**REZONING  
SITE PLAN**

**RIVER OAKS DR. @ CUMBERLAND BLVD.**  
A Master Planned Mixed Use Development

# Z-18

**ZONING COMMENTS:**

**Z1**  
SHEET

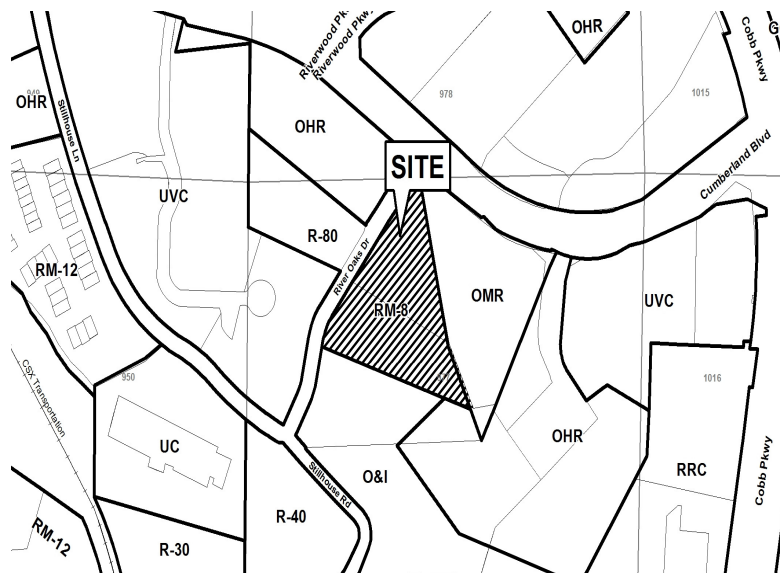
- No Stormwater controls shown \_\_\_\_\_
- Copy of survey is not current – Additional comments may be forthcoming when current site conditions are exposed.
- No site improvements showing on exhibit.

The site roadway configuration and retaining wall located in the right-of-way do not meet Cobb DOT standards.

The site roadway configuration and retaining wall do not meet Cobb County DOT standards. Recommend roadway design and retaining wall details to be determined during plan review, subject to Cobb County DOT approval.
